MONTGOMERY COUNTY
BOARD OF COMMISSIONERS

Re: MCPC #24-0254-002
Plan Name: Wawa Proposed Fly Thru
(1 lot comprising approximately 4 acres)
Situate: 1145 Virginia Drive (cross street: Office Center Drive)
Upper Dublin Township

REVIEW COMMENTS

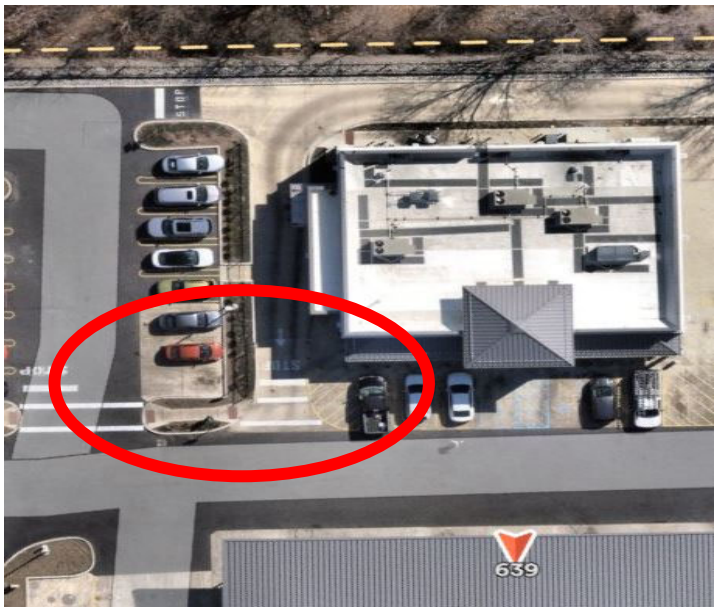
A. Drive-Through Aisle. The proposed drive-through aisle would be defined by painted stripes to delineate the aisle from the loading zone and the surrounding parking lot circulation. We offer the following recommendations to help improve the circulation of the site.

1. *Proximity to Loading Zone*. Based on the new plans provided, the loading zone has been revised and expanded to remove the larger queuing lane as it was shown on the previous plan set dated July 15, 2024. While the queueing lane has been removed in the current plans, it has also been significantly reduced in size. Removing the formal queuing lane and expanding the loading zone striping may help alleviate potential vehicular conflicts. However, the township may want the applicant to confirm if the current three space queuing is adequate for the amount of potential fly-thru traffic quantities.

Concept Sketch to Reduce Ped./Veh. Conflicts

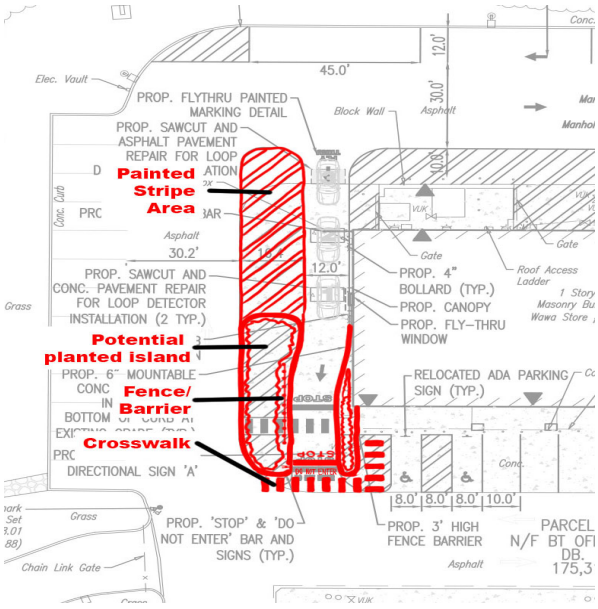
A pedestrian crosswalk is provided across the fly-thru lane; however, in its current design the crosswalk and dual stop bars create a pedestrian and vehicle conflict. Two stop signs and stop bars surround the crosswalk and do not provide the necessary distance for one stopped vehicle behind the stop bar at the exit of the fly-thru lane. The rear of a vehicle will overhang the crosswalk while waiting to exit the fly-thru lane. We recommend that the applicant adjust the site plan to reduce vehicular and pedestrian conflicts caused by the multiple stop bars in the fly-thru lane. Physical barriers such as landscaping and visually permeable fencing may be warranted to direct pedestrians around this conflict. As an example, below is an aerial image of a building with a drive-through in Langhorne, Bucks County. A concept sketch of how this could be implemented is also included below.
